Access Compliance Report

Public Rights-of-Way

(Curb Ramps)

Intersection ID: 47842	Main Street: MANITOBA_LN	Cross Street: CACTUS_VALLEY_RD	Location: NW
ADA ID: 0385BDD74154	Ramp Type: PerpDiag	Initial Pass/Fail: Fail	Overall Compliance: No
Severity Score: 12.5			
Codes/Mitigation Info/Possible Solution		Field Measurements/Component Compliance

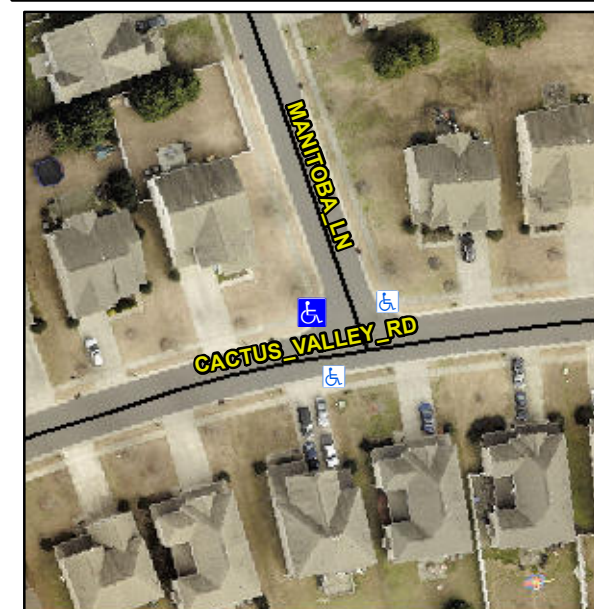
Compliance	Description	Data	Compliance	Description	Data
N/A	Ramp Length (in)	46.0	Yes	Ramp Slope (%)	5.2
Yes	Ramp Width (in)	48.0	No	Ramp XSlope (%)	5.1
N/A	Flare Type LT	N/A	N/A	Flare Type RT	N/A
N/A	Flare Slope LT (%)	N/A	N/A	Flare Slope RT (%)	N/A
N/A	Flare Traversable LT?	N/A	N/A	Flare Traversable RT?	N/A
N/A	Landing Length (in)	N/A	N/A	DWS Provided?	N/A
N/A	Landing Width (in)	N/A	N/A	DWS Contrast?	N/A
N/A	Landing Slope (%)	N/A	N/A	DWS Length (in)	N/A
N/A	Landing X Slope (%)	N/A	N/A	DWS Full Width?	N/A
N/A	Landing Curb? (Y/N)	N/A	N/A	DWS Offset (in)	N/A
N/A	Shared Landing?	N/A			
N/A	Gutter Ponding?	N/A	N/A	Gutter Slope (%)	N/A
N/A	Gutter Lip Ht (in)	N/A	N/A	Gutter X Slope (%)	N/A
N/A	Painted X Walk1?	No	N/A	Painted X Walk2?	No
	X Walk 1 Direction	To S		X Walk 2 Direction	To E
N/A	X Walk 1 Width (in)	N/A	N/A	X Walk 2 Width (in)	N/A
	X Walk 1 Slope (%)	0.0		X Walk 2 Slope (%)	1.9
	X Walk 1 X Slope (%)	1.6		X Walk 2 X Slope (%)	0.7

N/A	Ramp inside XWalk1?	N/A	N/A	Ramp inside XWalk2?	N/A
	Road Slope (%)	1.9	N/A	Clear Space?	N/A
	Road X Slope (%)	1.6	N/A	Clear Space to XWalk (in)	N/A
N/A	Any Obstructions?	N/A	N/A	Storm Grate/Utility Hazard?	N/A
	Obstruction Type			Storm Grate/Utility Type	
		N/A			N/A
		Yes		Surface Condition? (G/P)	Good

Remove & Replace Curb Ramp With Two New Directional Ramps or Equivalent.
